IX. STAFF RECOMMENDATIONS:

Staff recommends approval of DSUP #2014-0012 Map Amendment/Rezoning, Development Special Use Permit, and all associated applications subject to compliance with City codes, ordinances and staff recommendations below.

DEVELOPMENT SPECIAL USE PERMIT WITH SITE PLAN RECOMMENDATIONS

Tower 203 Turning Specifications

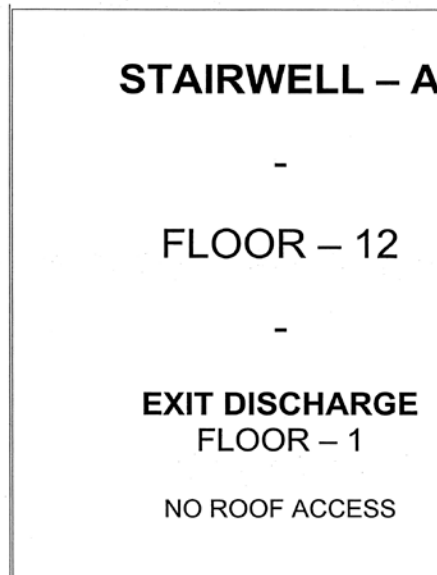
C-8 Show fire apparatus vehicle turning radius based on the following specifications:

- Turning Radius – Wall to Wall = 54.98 feet + / - 2 feet
Curb to Curb = 51.33 feet + / - 2 feet
Inside turning radius = 37.73 feet + / - 2 feet
- Overall Length – 47' – 4 1/2"
- Overall Width – 98"
- Wheel Bases from front axle to both rear axles – 240"
- Tandem axle spacing – 56" CL of axle to CL of axle
- Gross Weight – As built with no equipment or water gross weight = 66,000#
- Angle of Approach – 13 Degrees
- Angle of Departure – 11 degrees
- Ramp Break Over – Break over angle is 9°

Applicant has proposed additional life safety and fire protection enhancements to overcome lack of fire department access. The turning movement has been improved

and in conjunction with the enhancements will be acceptable. Overhang protruding into drive isle is no longer a problem.
